DOCUMENT NUMBER: 17-00173
ISSUE NUMBER: 1
ISSUE DATE: September, '97

Failure of 8580 to establish link OR very slow data transfer

This Service Bulletin refers to Codan 8580 modems used with a 9323/9360/9390/9780 transceiver.

Figure 1: Portion of Receiver/Exciter PCB

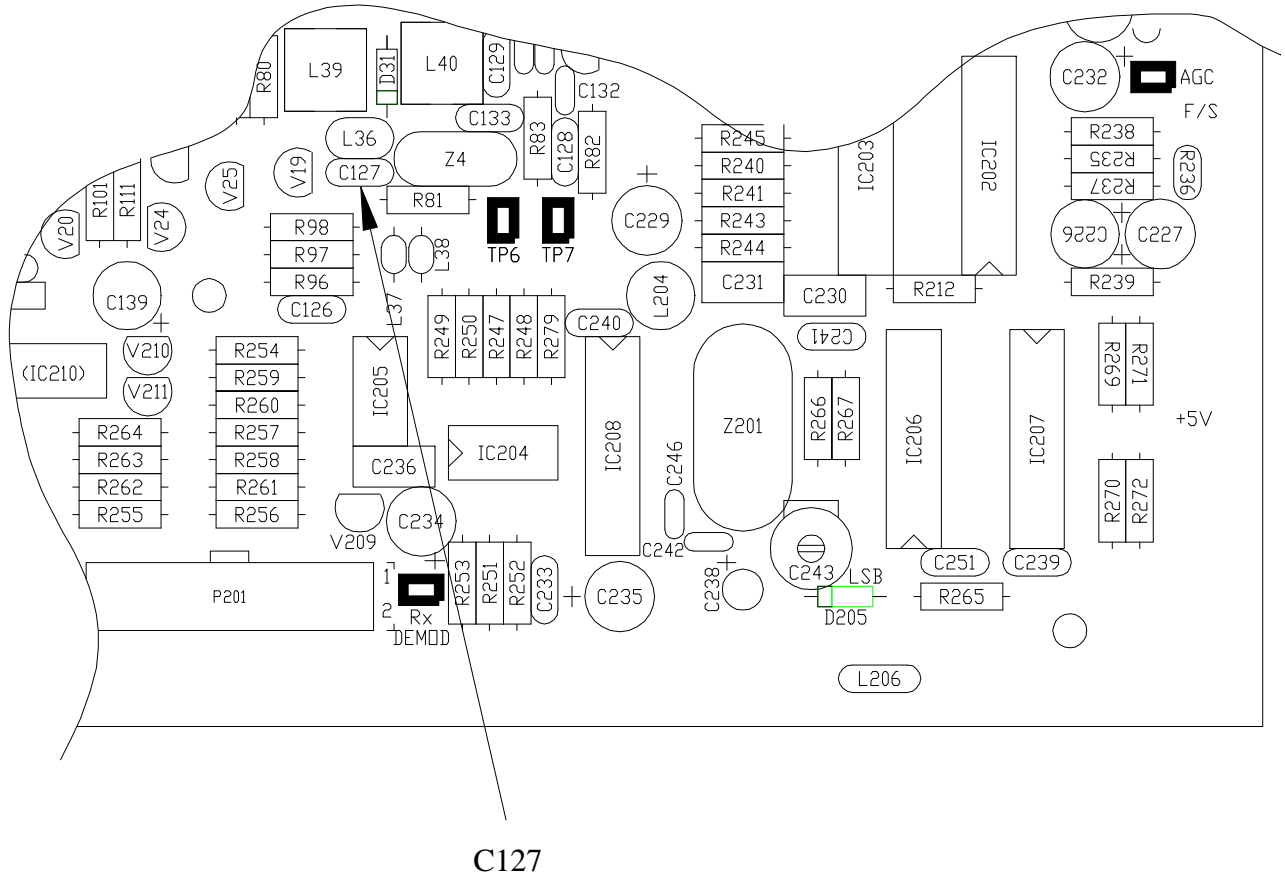
The modification involves the changing of a capacitor value on the Receiver/Exciter Printed Circuit Board (PCB), part number 08-05322-001 or 002.

1. Remove the transceiver from the installation.
2. Remove the top cover.
3. Disconnect the three plugs connected to the Receiver/Exciter PCB.
4. Remove the seven screws securing the PCB.
5. Withdraw the PCB from the chassis.
1. Locate C127, 33 nF. Refer Figure 1.

2. Using the appropriate desoldering tool, remove C127 from the PCB.
3. Replace C127 with a 220 pF capacitor.
4. Fit and secure the PCB into the chassis with the seven screws.
5. Refit the plugs ensuring the lead with the red identification (P502) connects to J2 (the connector closest to the large VCO1 can).
6. Fit the top cover and secure.
7. Reinstall the transceiver.
8. Connect power.
